## 1. PLUS Radios: HT-P and HT-PE

These sections describe the updates and known limitations in each software version for the HT-P and HT-PE PLUS Radios. The most recent version is listed first.

Figure 1: Security window - Reboot Interval list box

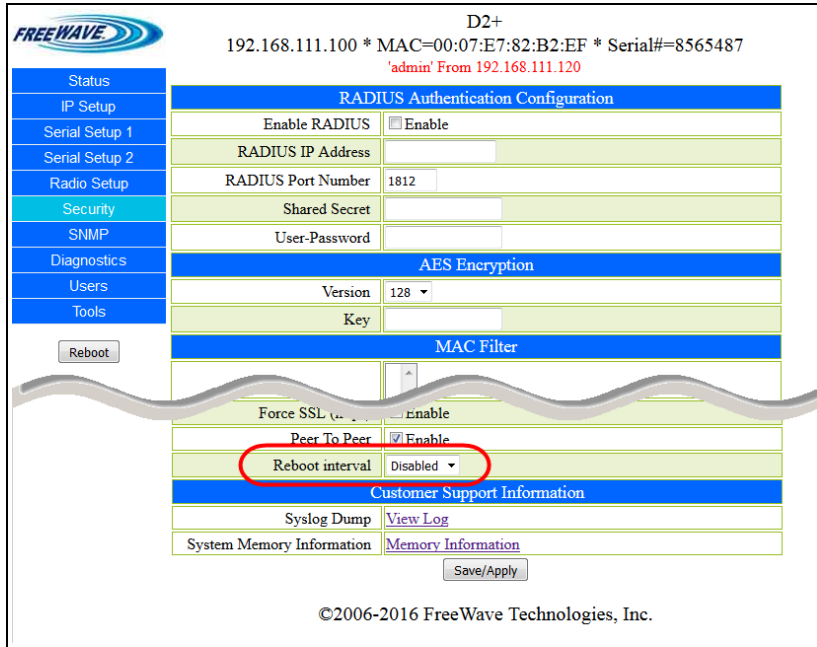
In the **Security** window, in the **Miscellaneous** area, a new **Reboot Interval** list box option has been added.

- By default, the **Reboot Interval** is **Disabled**.
  - If **Disabled** is selected, the PLUS Radio will operate without automatically rebooting.
  - When an interval (e.g., **1 Hour**, **1 Day**, **30 Days**) is selected, the scheduler automatically reboots the PLUS Radio when the reboot interval expires.
